New Reactors Division – Generic Design Assessment
Step 4 Assessment of Spent Fuel Interim Storage for the UK HPR1000 Reactor

Assessment Report ONR-NR-AR-21-017
Revision 0
January 2022

Figure 2: Indicative Structures of the Spent Fuel Storage Canister, Transfer Cask and Concrete Silo (Ref. 34)

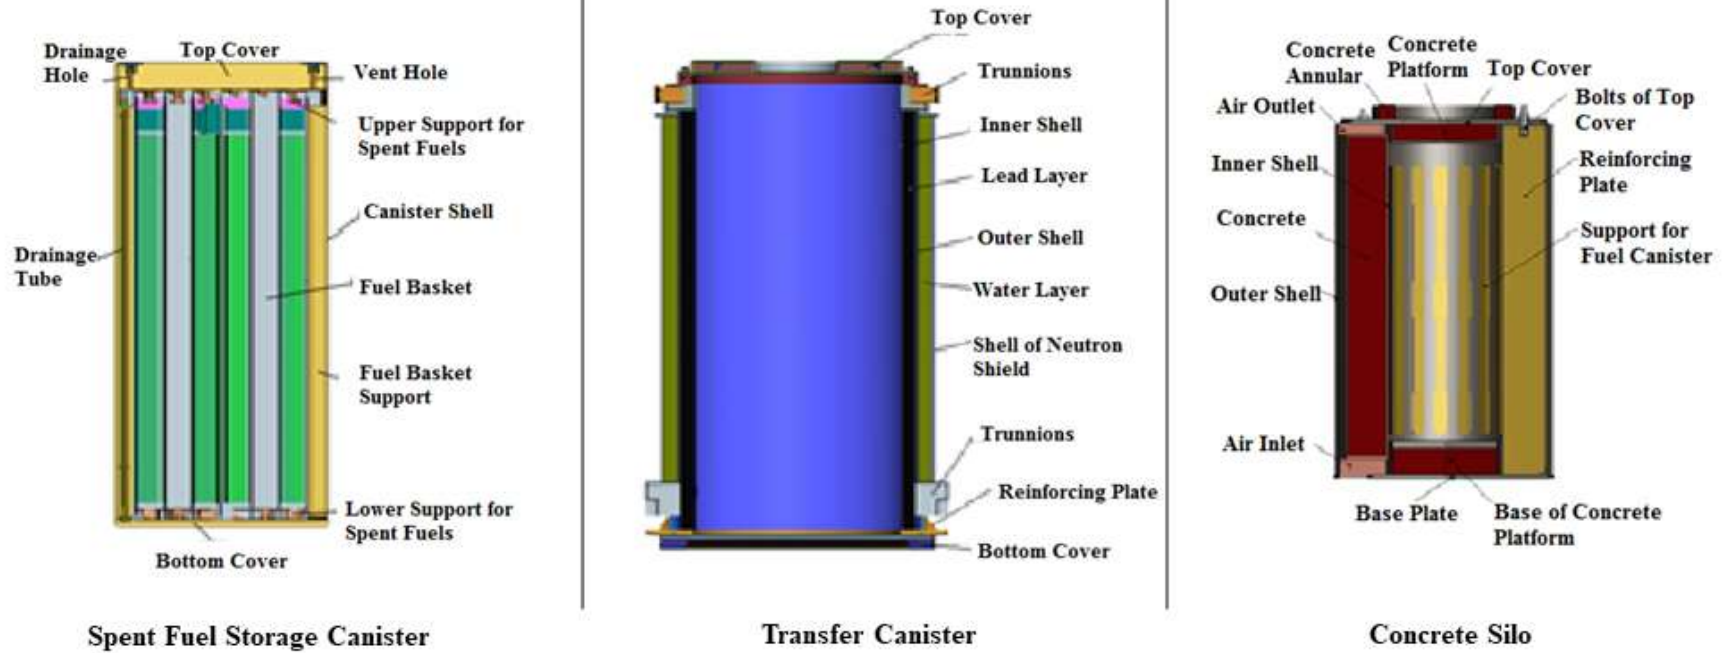
111. The RP's safety case identifies the need to define a time limit for spent fuel in the spent fuel storage canister/transfer cask configuration as part of the detailed design. This is due to the limited capability for the transfer cask to passively remove heat (Ref. 34). Passive features of the spent fuel storage canister and transfer cask to assist in the management of heat include consideration of material selection and the physical structure/design of the canister/cask to facilitate heat transfer.

114. The RP's safety case (Ref. 34) identifies the requirement for the SFIS design to include a concrete silo as an overpack during the storage of spent fuel within the storage canister. An indicative structure of the concrete silo is provided in Figure 2. The primary safety functional requirements of the concrete silo are radiation shielding and physical protection of the storage canister against internal and external hazards, however the design also needs to ensure that heat can be removed by passive means.

- The internal furniture (for example the fuel basket in Figure 2) within the spent fuel storage canister can be customised and the packing arrangements modified without impacting the external diameter of the storage canister. This would enable accommodation of failed fuel within a failed fuel can, if required, and again ensures the transfer cask and concrete silo remain compatible.

Figure 3: UK HPR1000 Fuel Building SFIS Processing Areas: Cross Sectional View

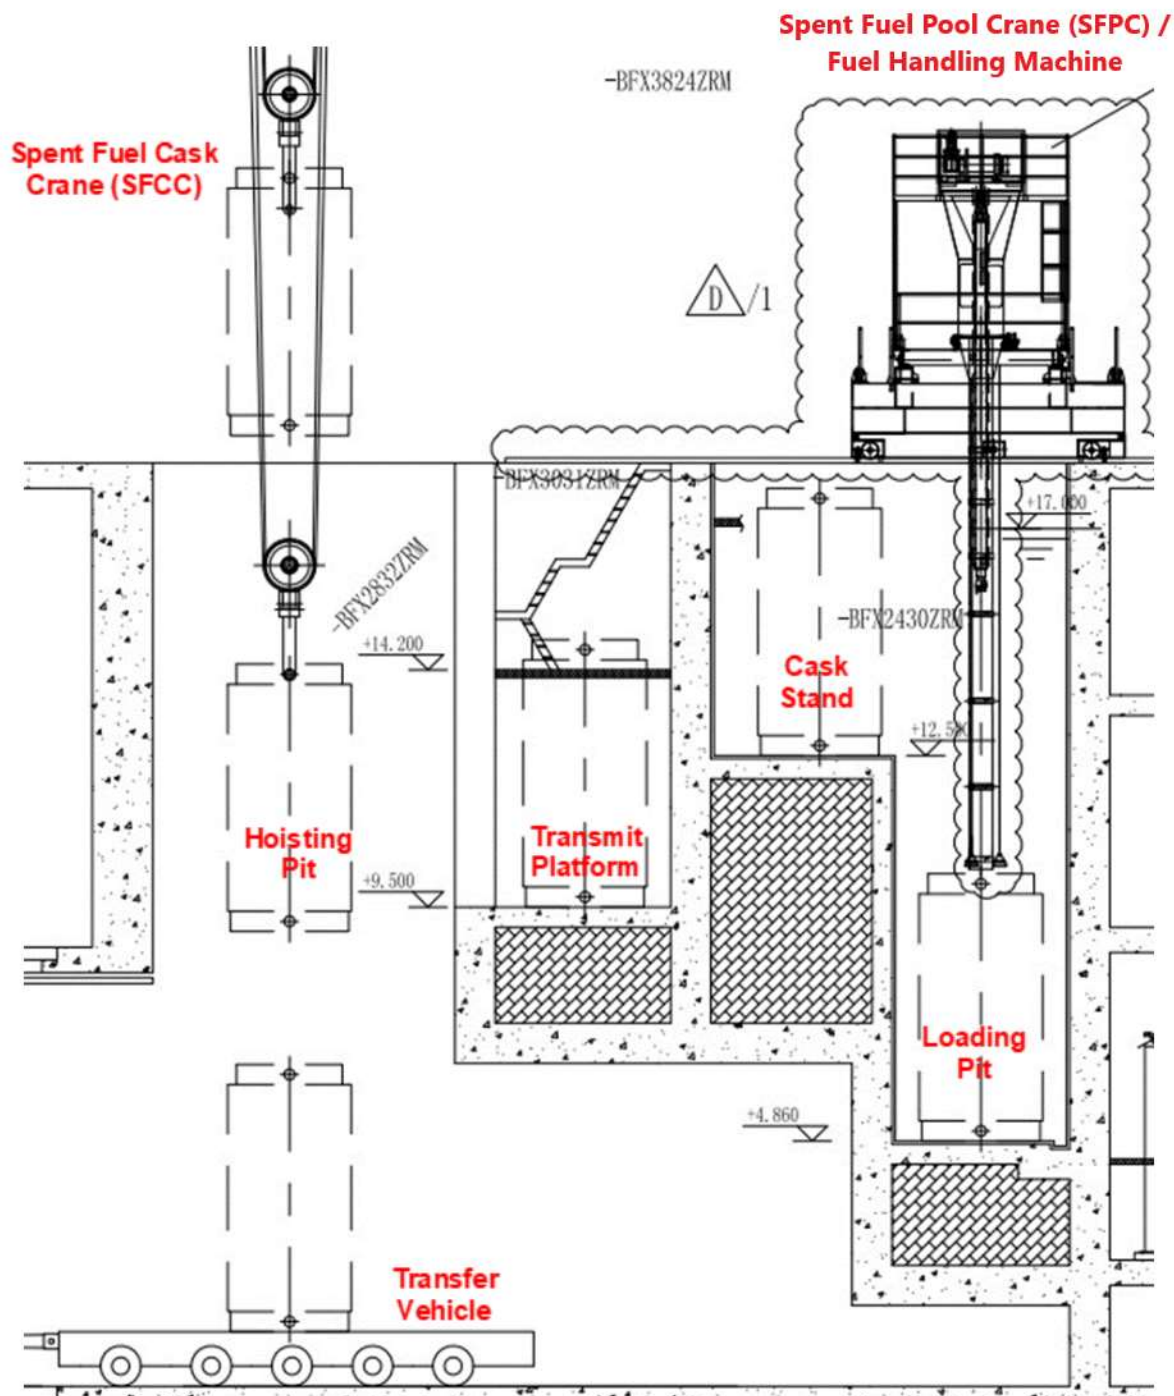
RQ-UKHPR1000-1759	Clarification of Assumptions in Disposability Assessment	Provided clarity on the basis for the assumptions used in the RWM disposability assessment.
RQ-UKHPR1000-1762	Fuel handling and storage system layout drawings	In response the RP provided copies of the layout drawings for facilities in the Fuel Building, see Figure 3.

- The adequacy of the space available for the handling of the transfer cask and transfer trailer, with the transfer cask in the vertical orientation (as the largest item). This is consistent with the processes highlighted in Figure 3 and has been assessed by the ONR Mechanical Engineering specialist inspector (Ref. 27).

Figure 4: Preliminary SFIS Facility Layout for the First Phase

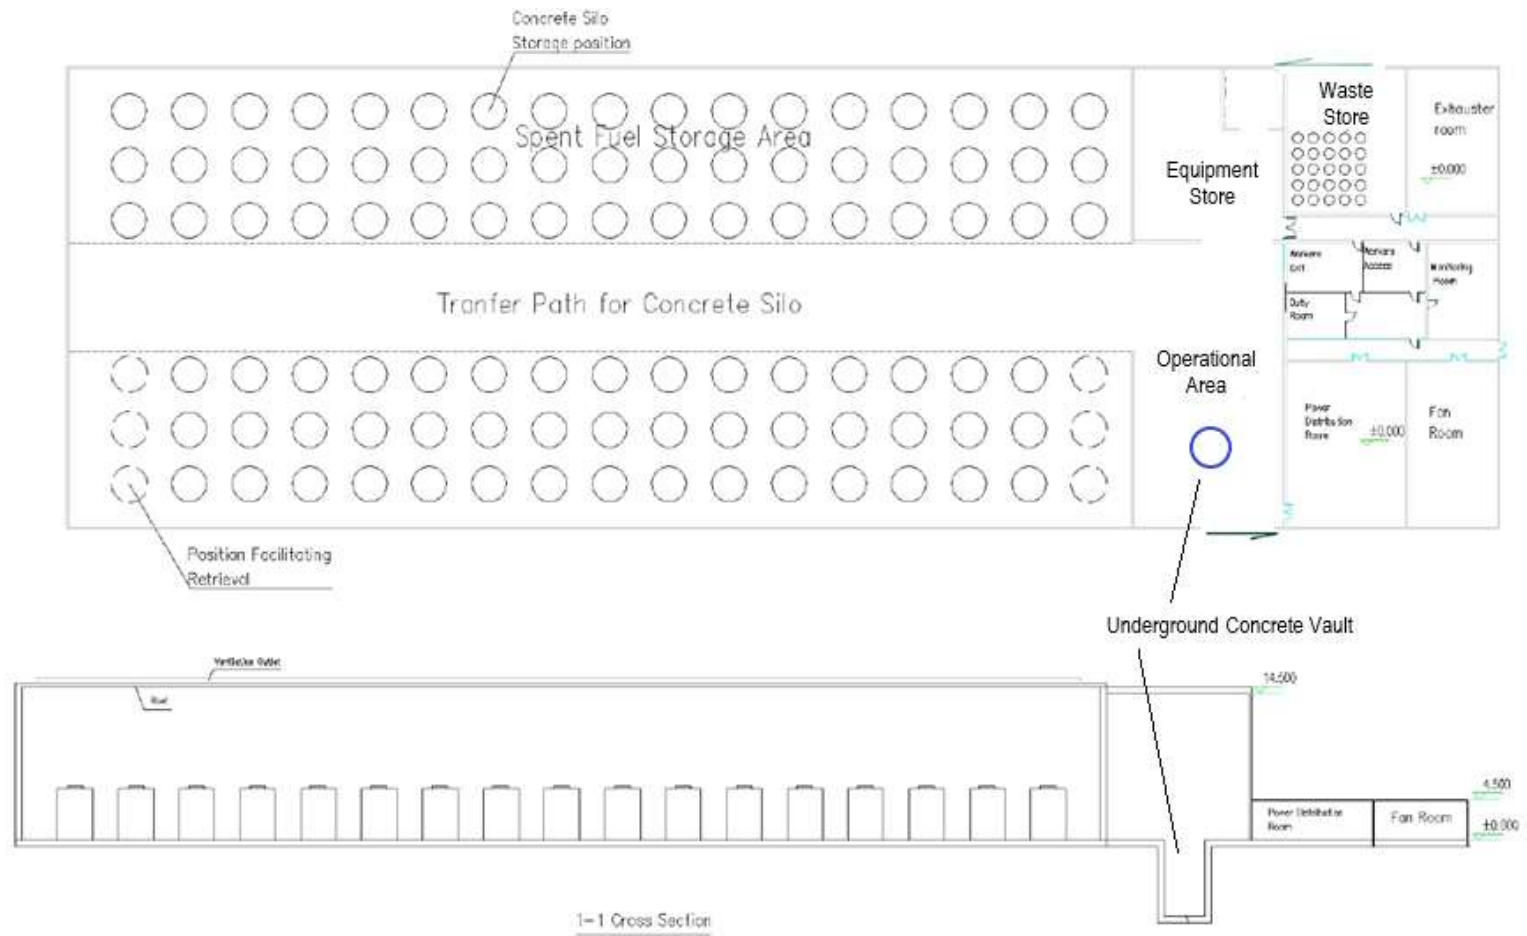
therefore only small quantities of failed fuel are anticipated. The number of spent fuel canisters defined for the spent fuel inventory (Table 2) is 94, in the preliminary design of the first phase of the SFIS Facility (Figure 4) storage locations for 102 canisters are identified, six of which are intended to be left empty to facilitate retrieval of a canister/concrete silo, if required. The inventory defined for the conceptual design of the first phase the SFIS Facility assumes failed fuel assemblies remain stored within the SFP, and that all failed fuel assemblies are transferred to SFIS in the spent fuel storage canisters for the second phase of the SFIS Facility.
